SUMMARY REPORT - PRIMARY PLANT MAKE UP STORAGE TANK UPGRADE

**PRIMARY PLANT MAKE UP STORAGE
TANK UPGRADE**

**SAN ONOFRE NUCLEAR GENERATING
STATION**

**RESPONSES TO QUESTIONS FROM NRC REVIEWERS
ON THE SAN ONOFRE UNITS 2 AND 3 PRIMARY PLANT MAKEUP TANK UPGRADE**

Figure 5.8 Hoop Stress Distribution in the Tank Shell

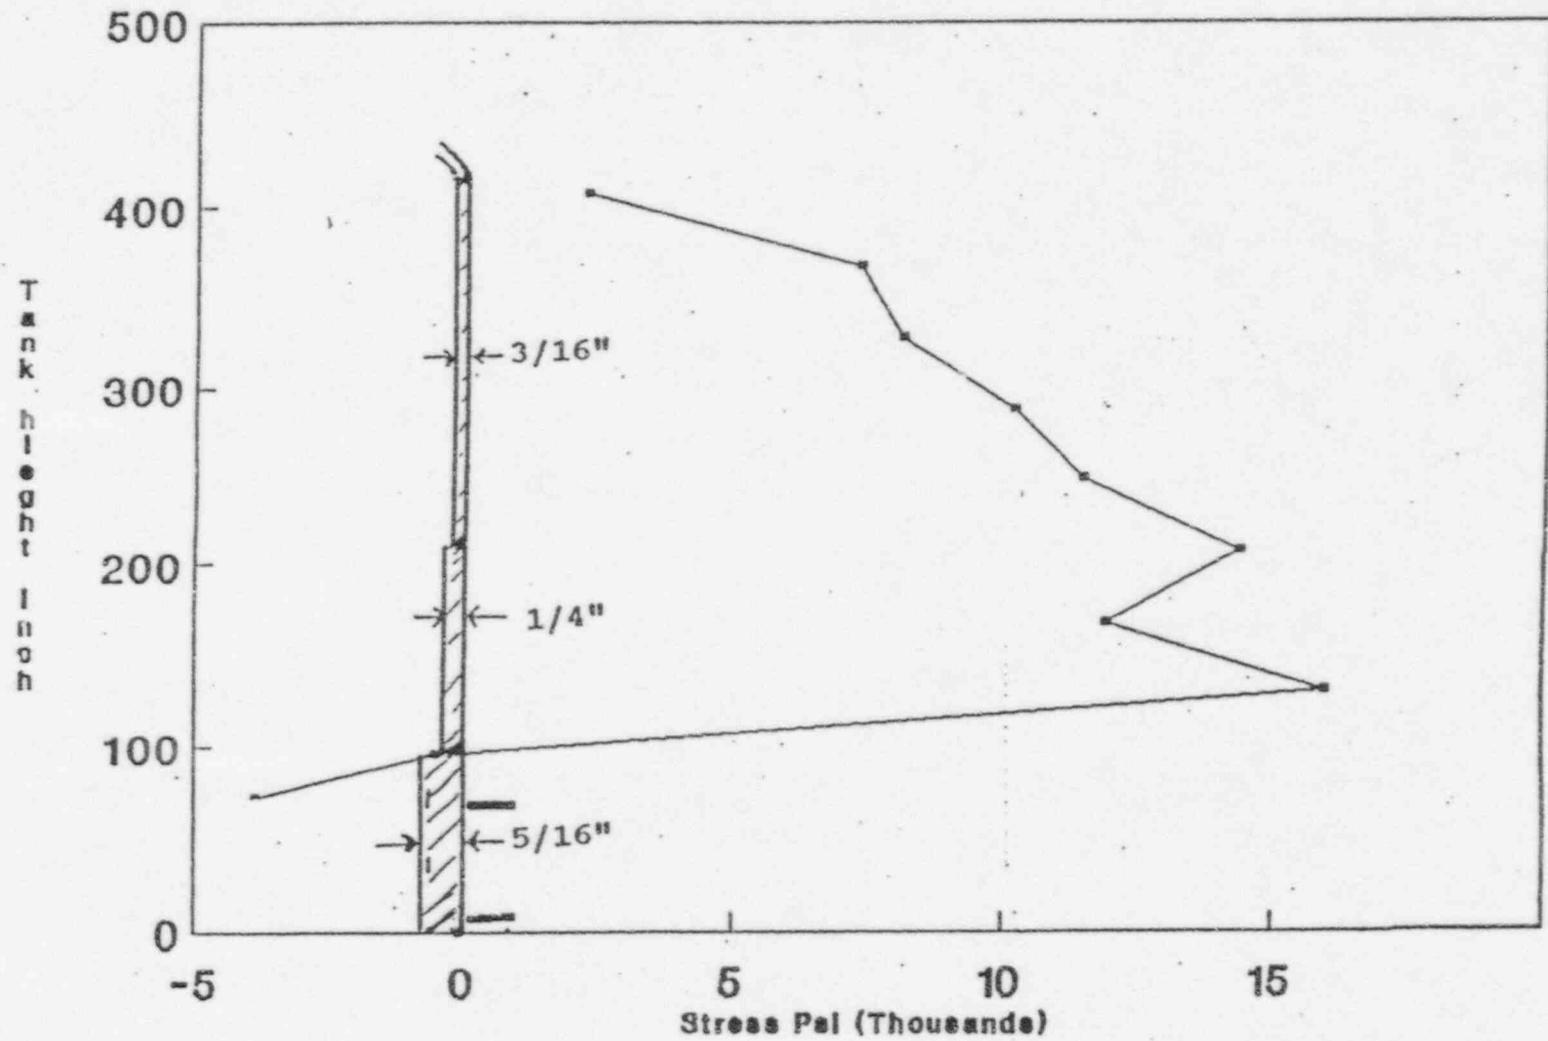
- (2) 8.1 STRESS CALCULATIONS, Sheet No. 277 - It was indicated that the loads, which produced the maximum hoop stress of 15.9 ksi from the tank FEM model, are the water sloshing SSE load and tank hydrostatic pressure. What about the inertia load of the tank itself under SSE loading? Provide a detailed definition and information about this water sloshing SSE load.

- (a) The hydrostatic pressure with the tank filled to its maximum capacity, and
- (b) The water sloshing component of 3.29 psi added to the hydrostatic pressure component. This value is based on DBE conditions.
